Expert Opinion Report - Rectification

10-12 View Point Road, McCrae

PSM5226-005R 11 June 2024

Inset 2: Excerpt from CivilTest report 1222044-1 Issue 2 (5 December 2022) (Document 2, pdf page 4)

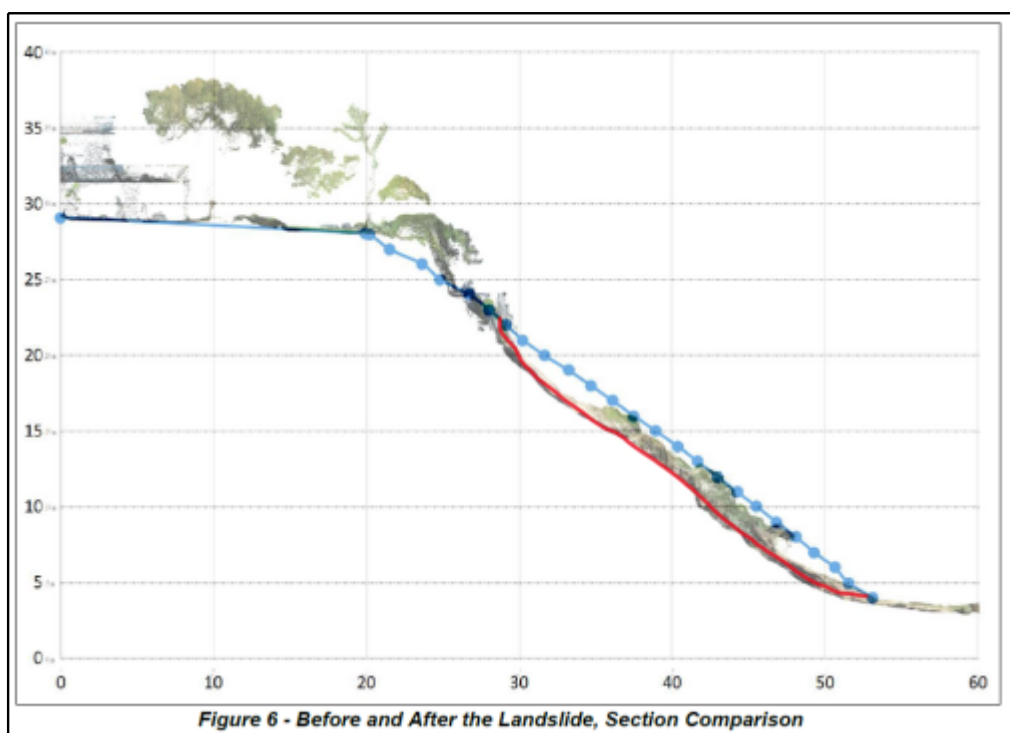
- (d) The steep head scarp depicted in CivilTest drone survey (Inset 2) and models (ref) is an artefact of creating a thick cross section line from the drone model. i.e. the head scarp feature depicted by CivilTest at the crest of the escarpment does not exist on Site (refer to Paragraph [9(a)]).

Inset 3: CivilTest description of debris flow as “fill” (Document 9, pdf page 3)

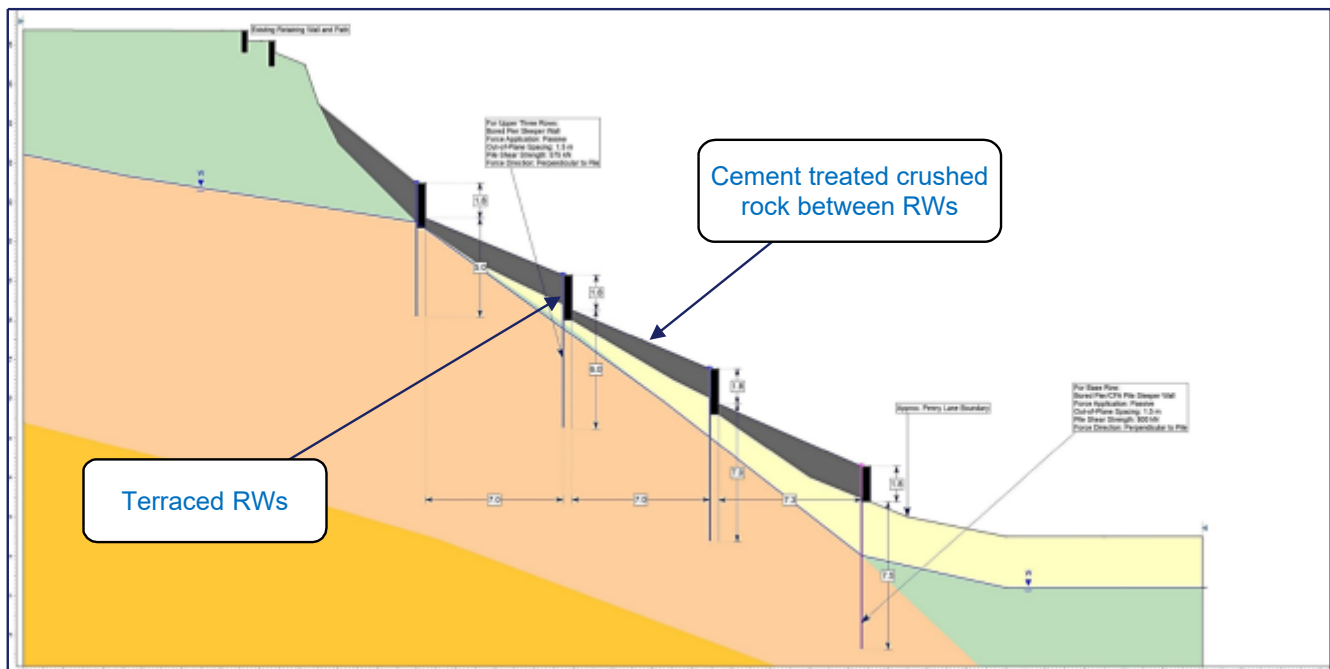
- (b) Boreholes 1 and 2 encountered landslide debris 1.2 m and 0.7 m thick respectively (Appendix C, pdf pages 29 to 30). I have assumed that all fill reported at the toe of the slope is landslide debris.
